Access Compliance Report

Public Rights-of-Way

Intersection ID: 44210	Main Street: MOCKERNUT_DR	Cross Street: PINACEAL_CT	Location: SW
ADA ID: 0A64F0141215	Ramp Type: PerpDiag	Initial Pass/Fail: Fail	Overall Compliance: No
			Severity Score: 33.75

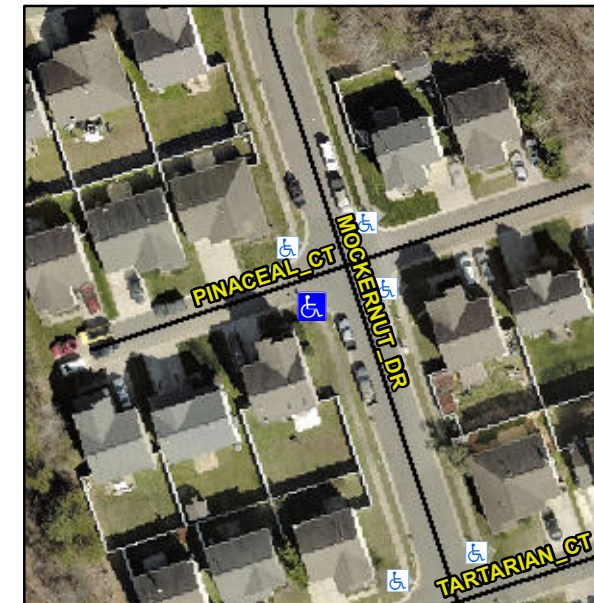
Not Found, R304.5.1, R304.2.2, R304.5.3

Compliance	Description	Data	Compliance	Description	Data
N/A	Ramp Length (in)	49.0	No	Ramp Slope (%)	11.2
No	Ramp Width (in)	47.5	No	Ramp XSlope (%)	5.5
N/A	Flare Type LT	N/A	N/A	Flare Type RT	N/A
N/A	Flare Slope LT (%)	N/A	N/A	Flare Slope RT (%)	N/A
N/A	Flare Traversable LT?	N/A	N/A	Flare Traversable RT?	N/A
N/A	Landing Length (in)	N/A	N/A	DWS Provided?	N/A
N/A	Landing Width (in)	N/A	N/A	DWS Contrast?	N/A
N/A	Landing Slope (%)	N/A	N/A	DWS Length (in)	N/A
N/A	Landing X Slope (%)	N/A	N/A	DWS Full Width?	N/A
N/A	Landing Curb? (Y/N)	N/A	N/A	DWS Offset (in)	N/A
N/A	Shared Landing?	N/A			
N/A	Gutter Ponding?	N/A	N/A	Gutter Slope (%)	N/A
N/A	Gutter Lip Ht (in)	N/A	N/A	Gutter X Slope (%)	N/A
N/A	Painted X Walk1?	No	N/A	Painted X Walk2?	No
	X Walk 1 Direction	To E		X Walk 2 Direction	To N
N/A	X Walk 1 Width (in)	N/A	N/A	X Walk 2 Width (in)	N/A
	X Walk 1 Slope (%)	1.1		X Walk 2 Slope (%)	1.4
	X Walk 1 X Slope (%)	2.5		X Walk 2 X Slope (%)	0.1

Remove & Replace Curb Ramp With Two New Directional Ramps or Equivalent.
